**HORIZONTAL DIRECTIONAL DRILL ANALYSIS
WILLIAM PENN AVENUE CROSSING
PADEP SECTION 105 PERMIT NO.: E11-352
PA-CA-0023.0000-RD and PA-CA-0023.0000-RD-16
(SPLP HDD No. S2-0070)**

**WILLIAM PENN AVENUE CROSSING
PADEP SECTION 105 PERMIT NO.: E11-352
PA-CA-0023.0000-RD and PA-CA-0023.0000-RD-16
(SPLP HDD No. S2-0070)**

CAMBRIA COUNTY, PENNSYLVANIA - JACKSON TOWNSHIP
S2-0070

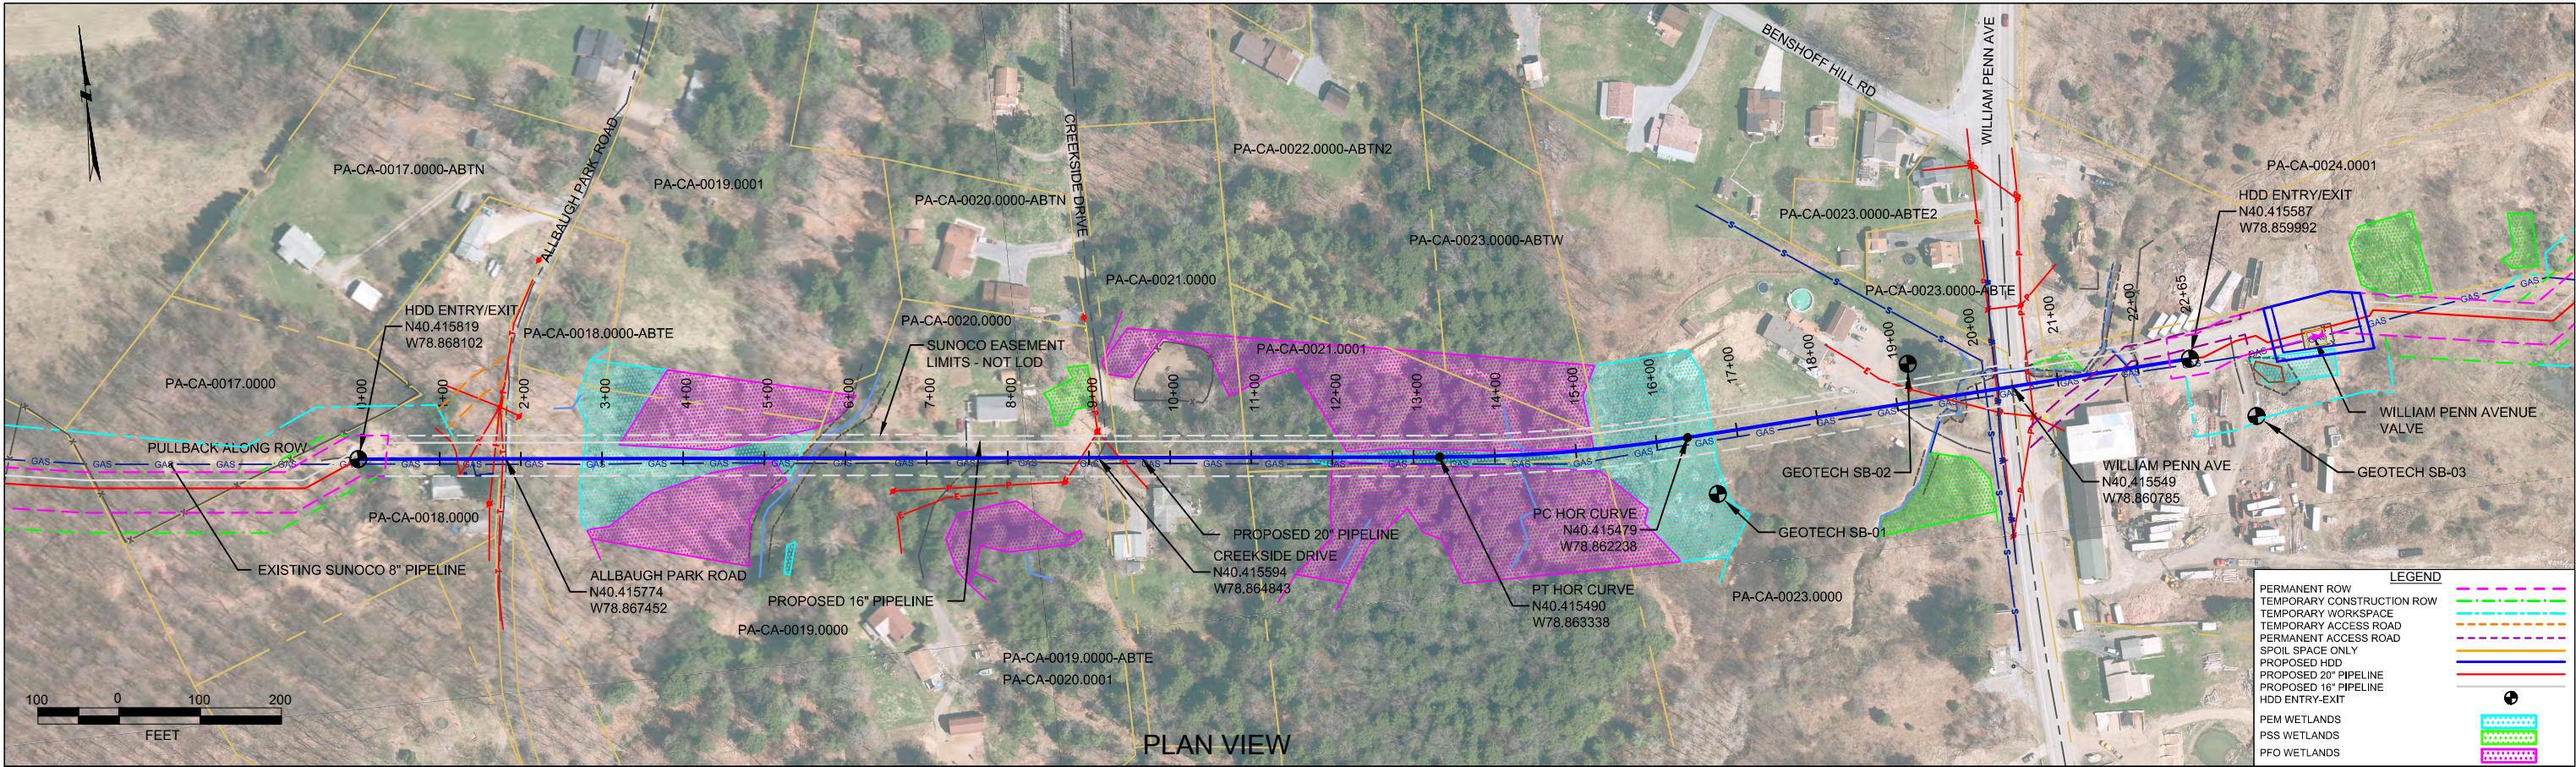
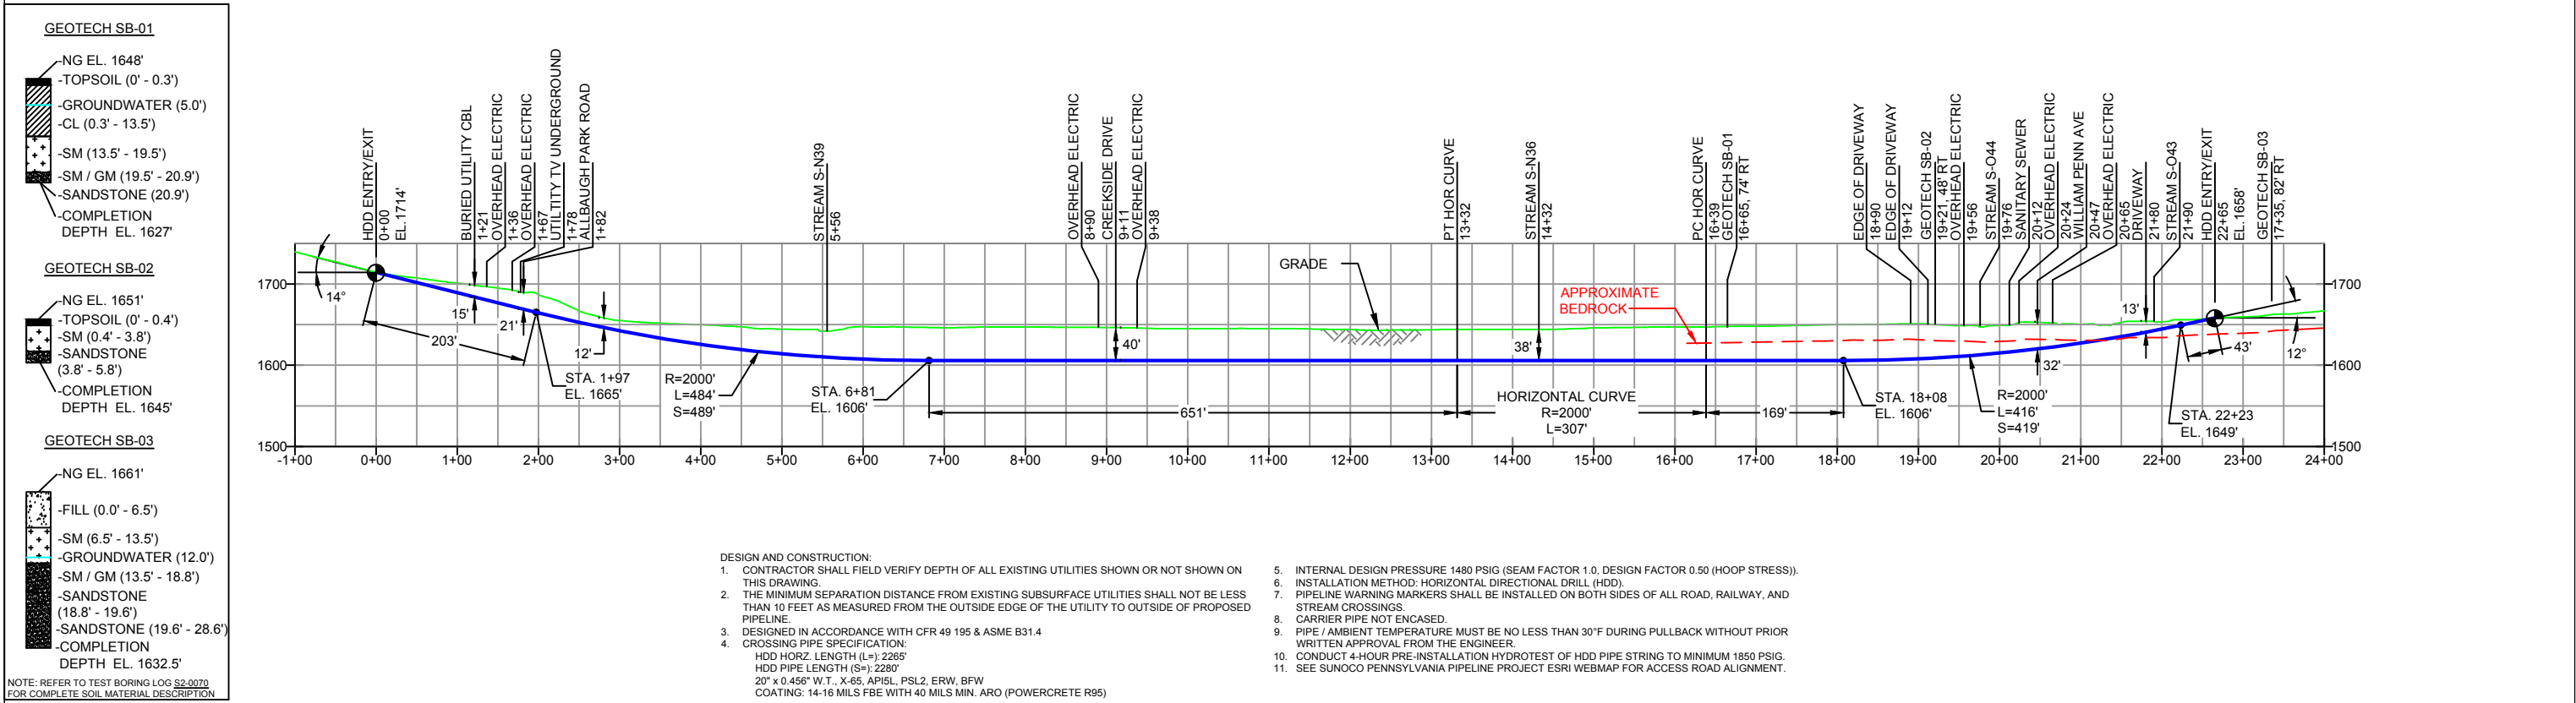
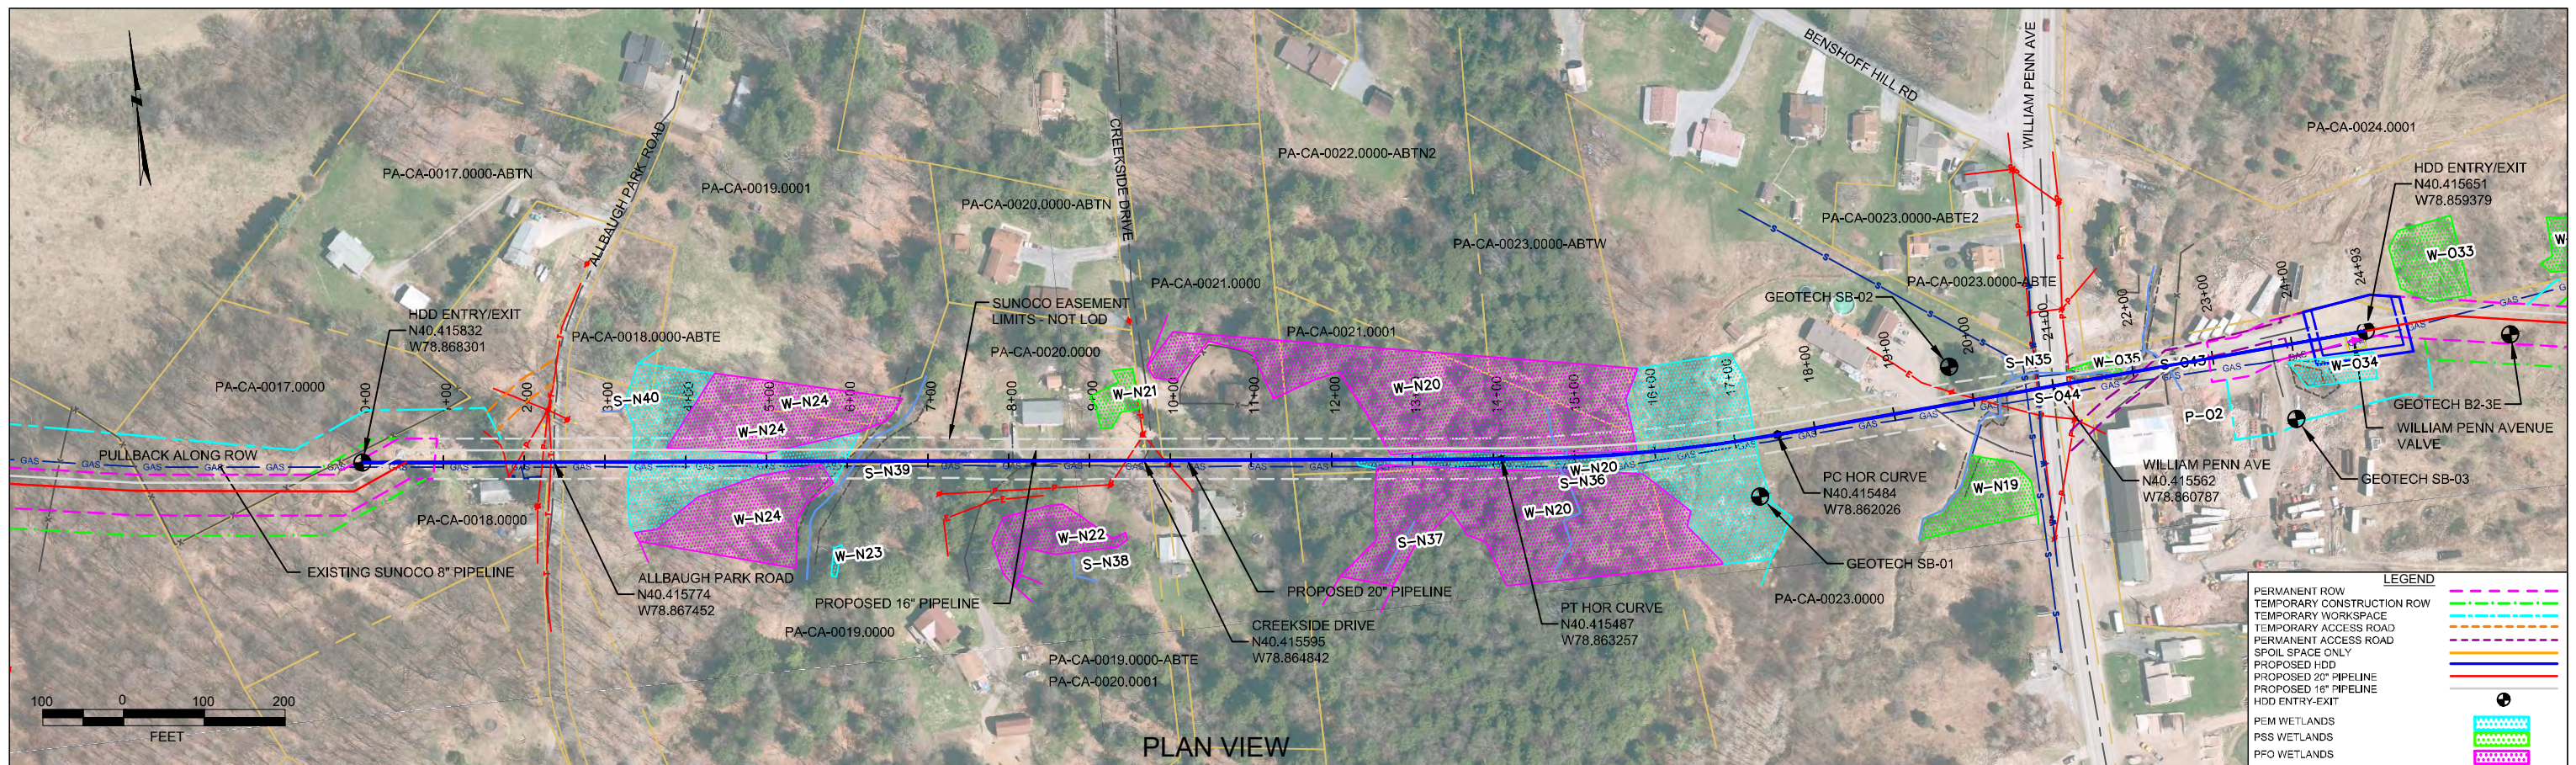
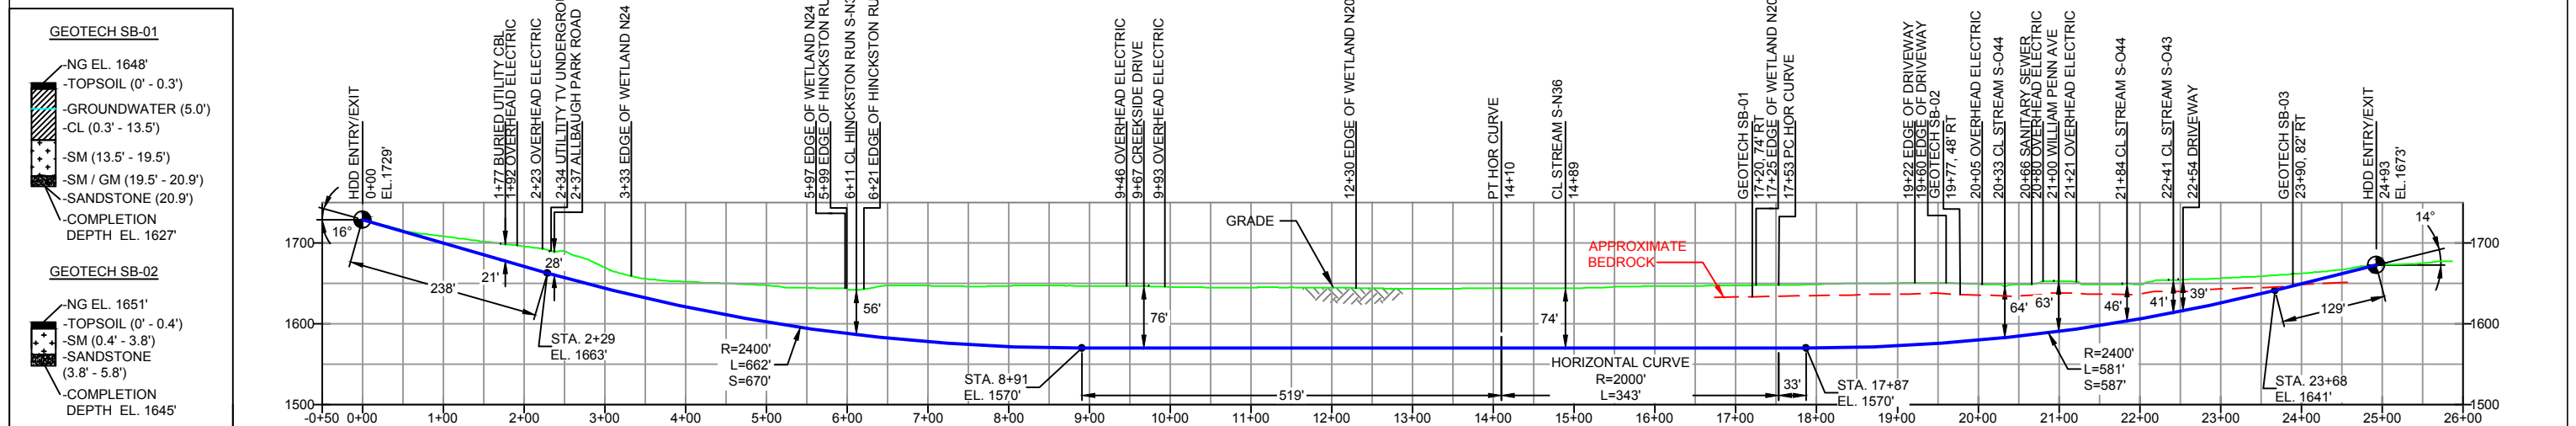
The redesigned HDD profile for the 20-inch pipeline is 228 ft longer, with a depth of cover below the streams and wetlands increased by 14-38 ft from the permitted design. In addition, the entry/exit angles have been increased allowing for a sharper and quicker descent into more competent rock. The redesigned HDD profile for the 16-inch pipeline is 171 ft longer, with a depth of cover below the streams and wetlands increased by 20-47 ft and designed for a sharp and quick entry and exit from the horizontal depth.

It is SPLP's intent to modify the original profile design and to pursue a deeper and longer HDD profile. Figure 1 and 3 in Attachment 3 presents the original HDD plan and profiles. Figure 2 and 4 in Attachment 3 present the revised HDD plan and profiles.

Revised Horizontal Directional Drill Design Summary: 20-inch

- Horizontal length: 2,493 foot (ft)
- Entry/Exit angle: 14-16 degrees
- Maximum Depth of cover: 76 ft
- Depth under William Penn Ave: 63 ft
- Depth under streams: 41-56 ft
- Depth under wetlands: 26-76 ft
- Pipe design radius: 2,400 ft
